USB 3.0 ENGINEERING CHANGE NOTICE

ECN# 009

Title: USB3.0 Standard-B Connector Near End Crosstalk Applied to: USB3.0 (11132008)-final and ECN# 002

Figure 5-24. Differential Near-End Crosstalk Requirement between SuperSpeed Pairs

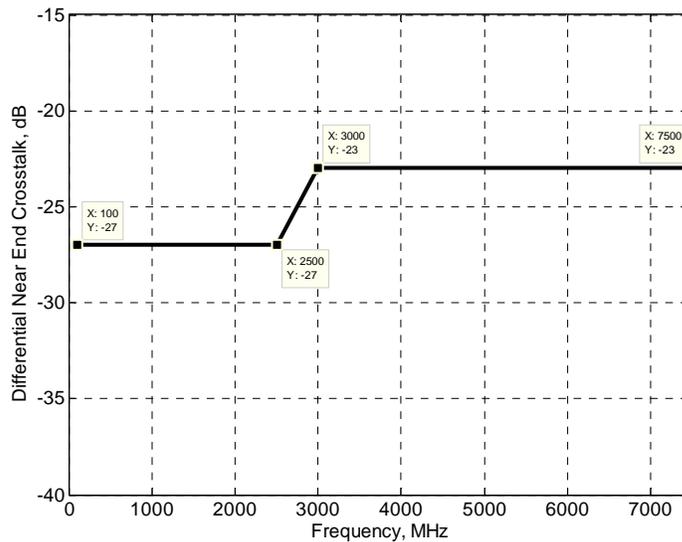
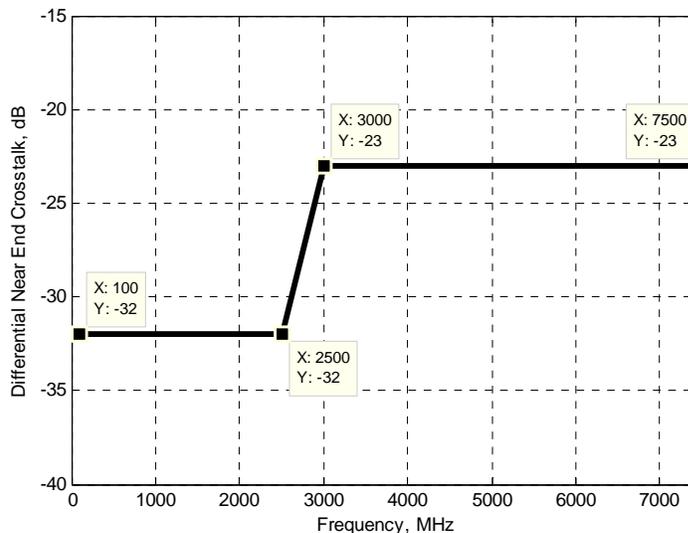
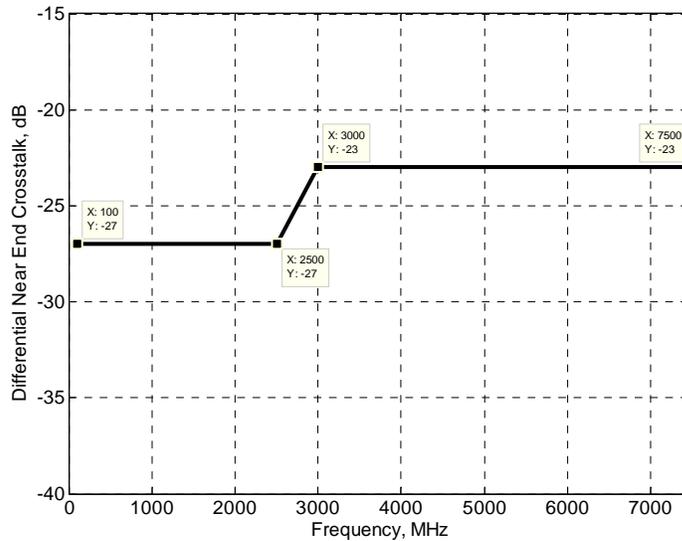
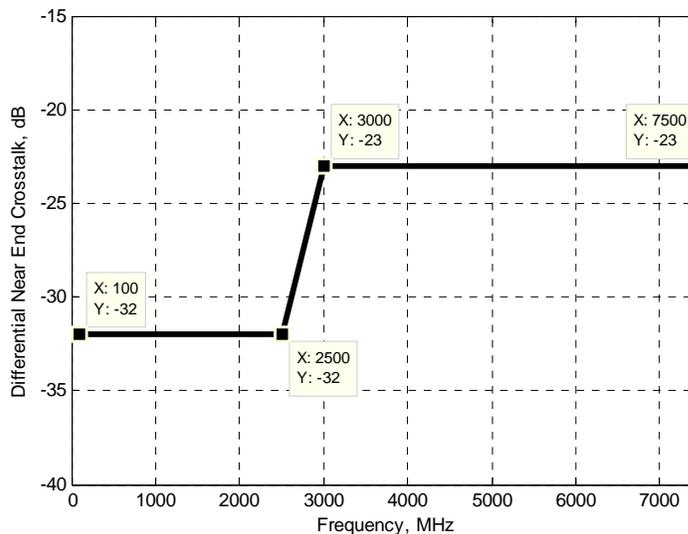
The near end crosstalk between SuperSpeed pairs became stricter from -27 dB to -32 dB from Rev 1.0 to ECN# 002, since it can give more solution space for USB3 channels. It was found recently that most connector vendors had a lot of difficulties to meet the -32 dB requirement, just at a few frequencies. Thus it is decided to add a near end crosstalk requirement in time domain to characterize the real impact of the out-of-spec frequency domain contents. The change only applies to the Standard-B and Powered-B connector.

(a). From Text (and location): Section 5.6.1.3.2, Page 5-50

For the USB3.0 Standard-B and Powered-B connectors: If a Standard-B or Powered-B connector fails to meet the -32 dB requirement in frequency domain shown in Figure 5-24 (b), but is able to meet the -27dB requirement shown in Figure 5-24(a), the measurement of DDNEXT in time domain will be required. The peak-to-peak value of DDNEXT in time domain shall not exceeds 1.5% of the input voltage swing (as shown in Figure 5-24 (c)), as seen from a 50 ps (20%-80%) rise time of a differential Time Domain Transmission (TDT) at TP1 or TP2 (as shown in Figure 5-22). Note that removing fixture effect is not required for the time domain measurements. If a Standard-B or Powered-B connector fails to meet the -27 dB requirement shown in Figure 5-24(a), it shall be considered non-compliance.
